RESPONSE TO REQUEST FOR ADDITIONAL INFORMATION

US-APWR Design Certification

Docket No.52-021

RAI NO.: NO. 750-5675 REVISION 2
SRP SECTION: 19 – Probabilistic Risk Assessment and Severe Accident Evaluation
APPLICATION SECTION: 19
DATE OF RAI ISSUE: 04/28/2011

Figure 19.513-7 Event Tree (Loss of Offsite Power [1/4])
(Same as DCD Figure 19.1-1 Sheet 13 of 19)

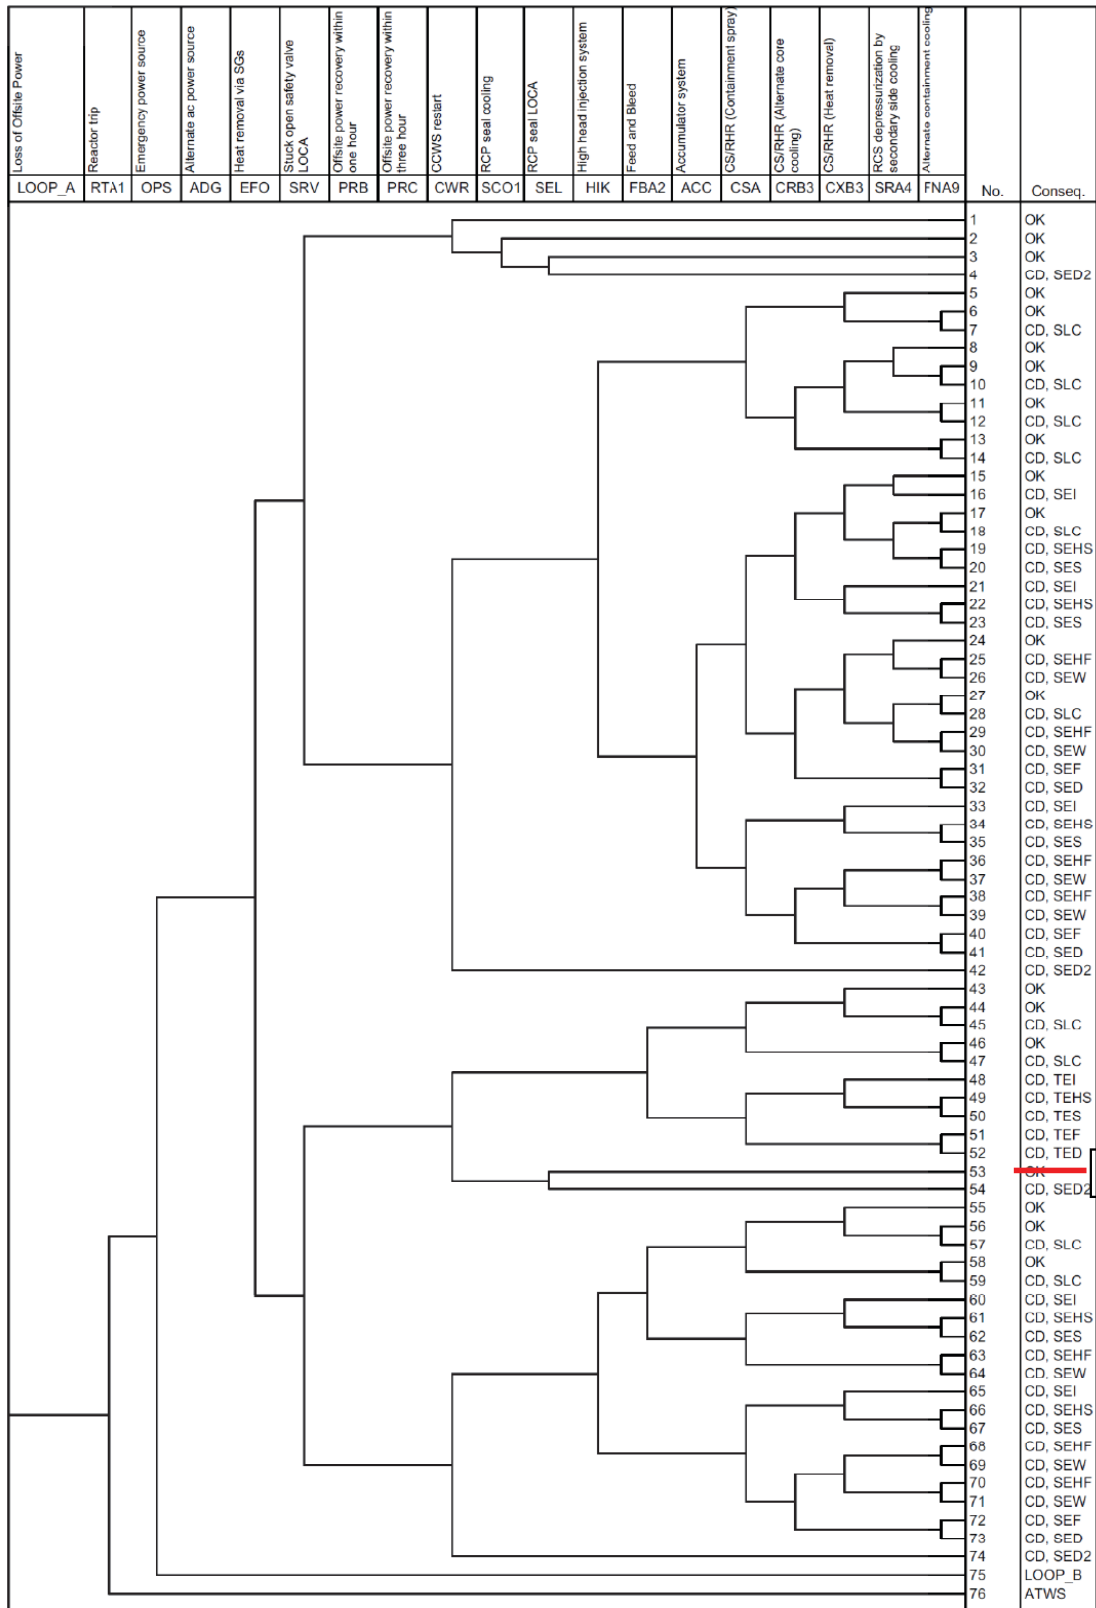
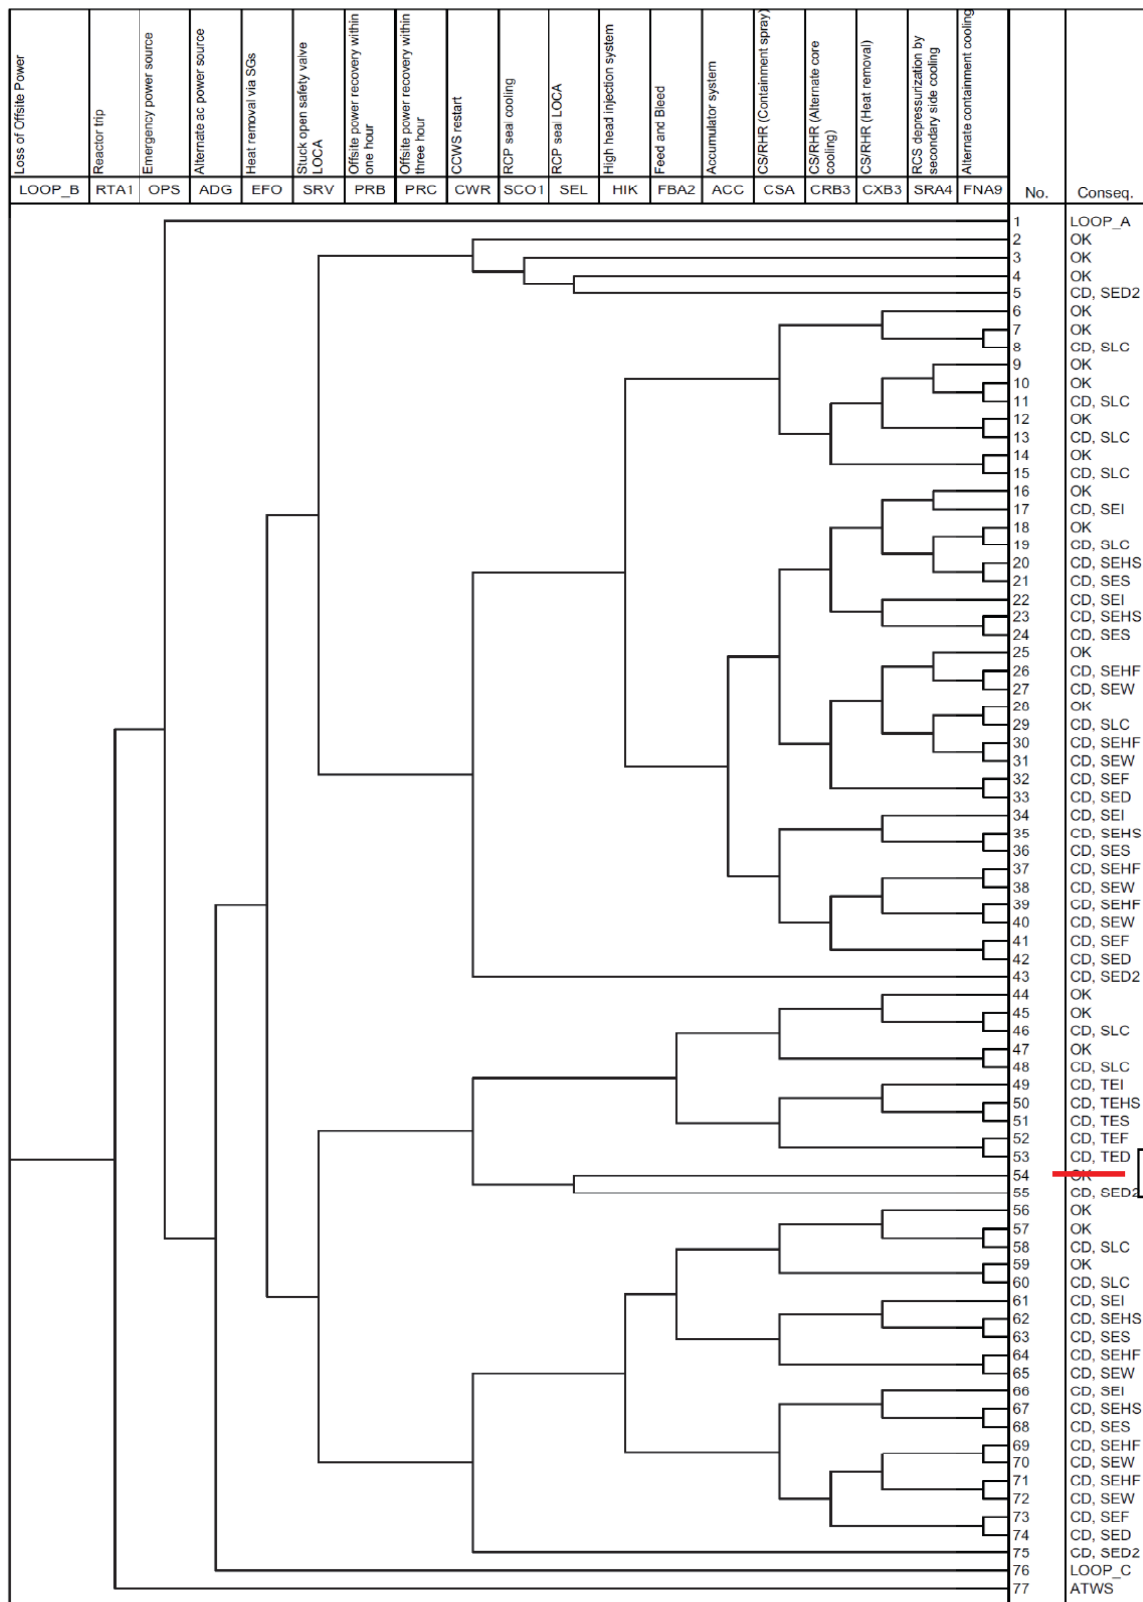
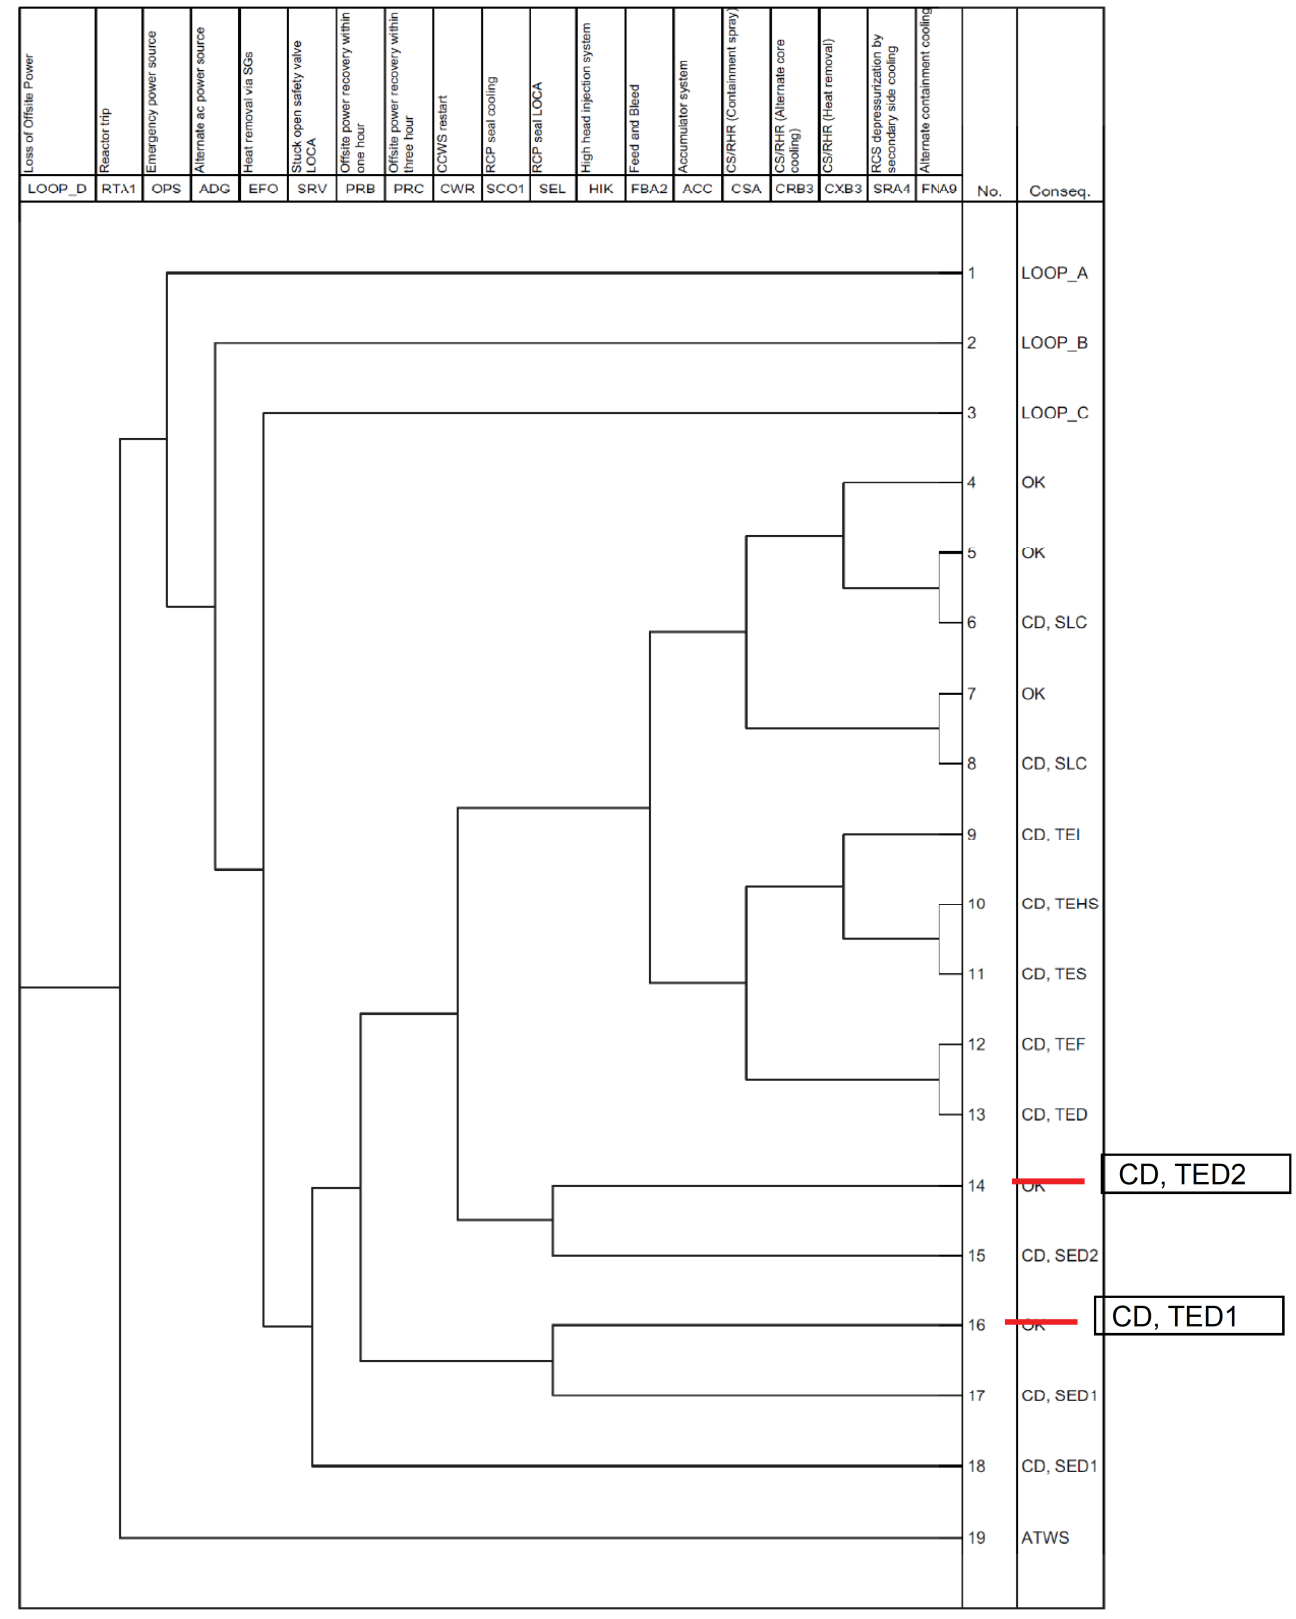
In addition to the operator actions mentioned above, there are some typographical errors in the loss of offsite power (LOOP) event tree (DCD Rev. 4 Figure 19.1-1 Sheets 13, 14 and 16) and the tree will be revised as depicted in Figure 19.513-7. However, these changes do not affect the calculated CDF because the PRA assumes a probability of 1.0 for RCP seal LOCA. Also, Table 19.1-15 will be corrected to replace "MSRV" used in DCD Rev. 4 with "MSDV", where appropriate.

The PRA results in the DCD will be updated as part of the next revision of the PRA. After the PRA is revised, then DCD Figure 19.1-1 sheets 5, 13, 14, and 16 will be revised as described in this amended response (note that the revision to sheet 5 also includes the discussion in the amended response to RAI 750-5675 Question 19-514).

Figure 19.514-2 Time Variation of the Ruptured SG Water Volume

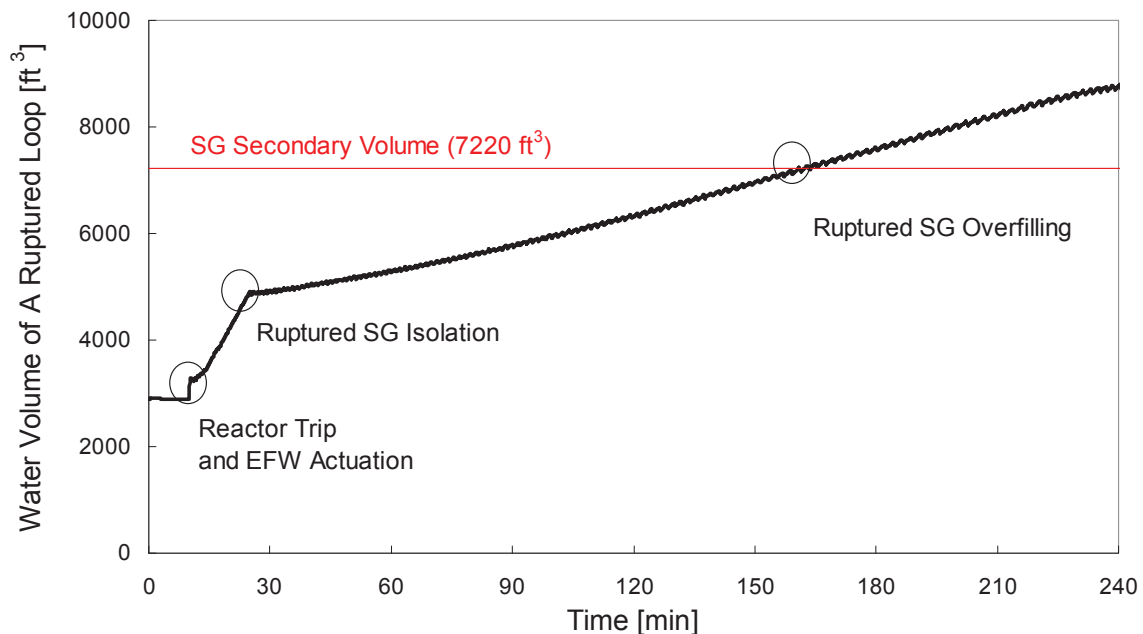
Table 19.514-1 and Figure 19.514-2 show the analysis results and time variation of the ruptured SG water volume, respectively. The estimated time to SG overfill following a SGTR event is approximately 2.7 hours after event initiation and the allowable time for these operator actions is more than 2 hours after operators detect the reactor trip. For the scenario in which the operator successfully isolates the ruptured loop, any one of the four aforementioned operator actions plus termination of SI will result in successful depressurization. The analysis result will be added in DCD Table 19.1-15, No. 3.7.
